Rebuttal to Proposals to Shift 802.3dj TX/RX OMA Requirements

Brian Welch (Cisco)

Mark Kimber (Semtech)

From fan_3dj_01a_2603

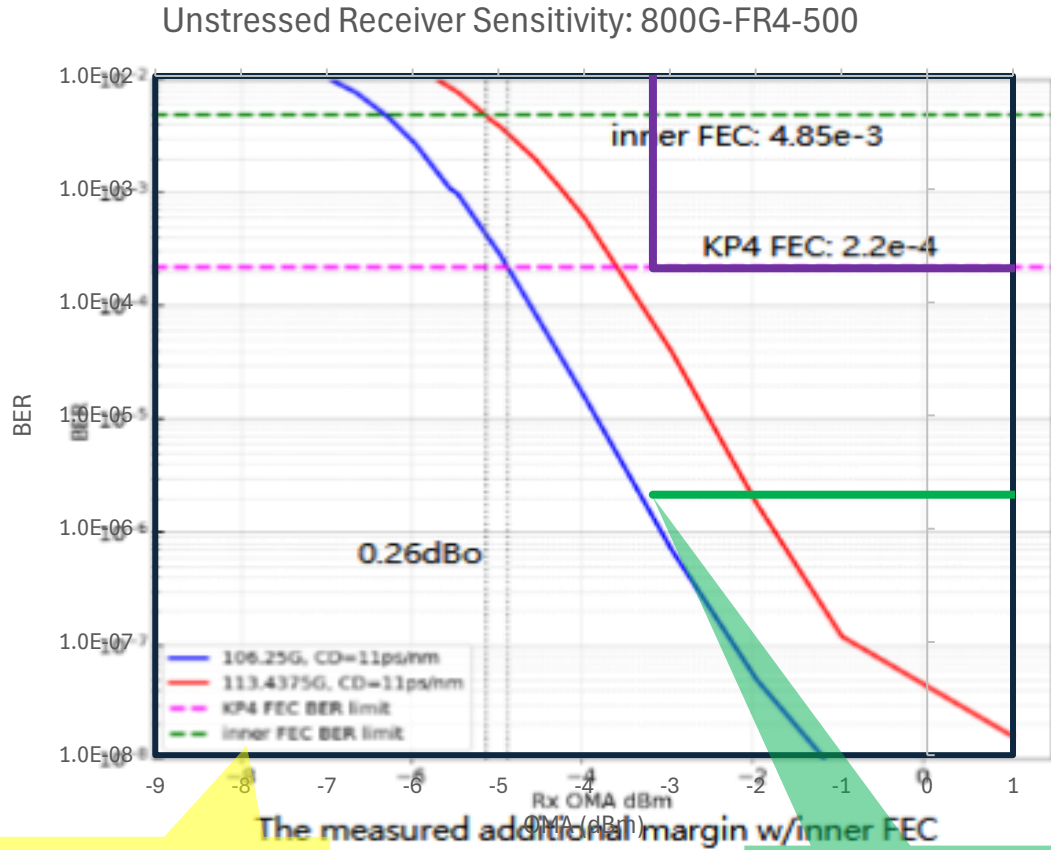
- He_3dj_01_2603 and Fan_3dj_01a_2603 both proposed shifting TX and RX OMA specifications, making RX OMA specifications more stringent.
- He_3dj_01_2603 only showed OMA (dBm) margin, BER margin not reported.
- Fan_3dj_01a_2603 showed OMA vs. BER, with BER margin just (barely) meeting customer requirements/expectations.

No margin to customer requirements
